Product Change Notification

Product Change Notification: E-20-010239

OUAZ series

before change

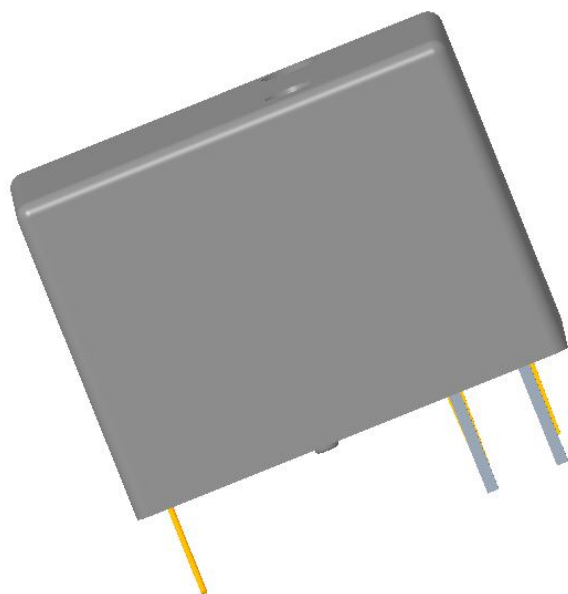
Four convex hulls are added to the case of the product for installation and positioning

after change

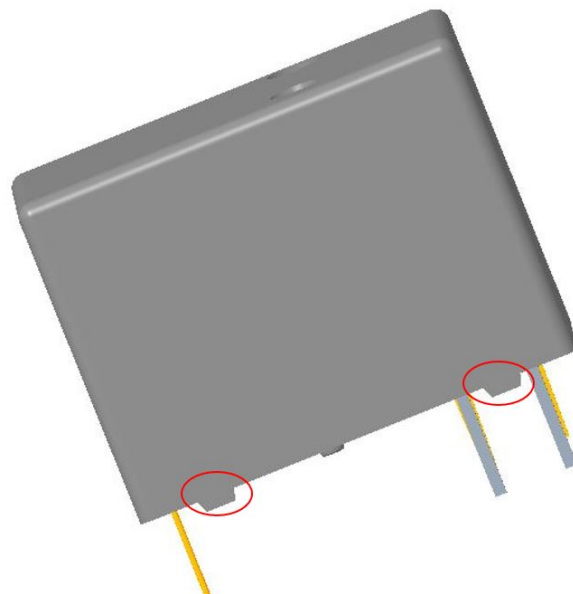
Product Improvement. TE is constantly innovating and optimizing to provide more reliable products to customers, Adding convex hulls to the case helps product installation and reduces the impact of terminal climbing epoxy on product installation. Product performance will not be affected;
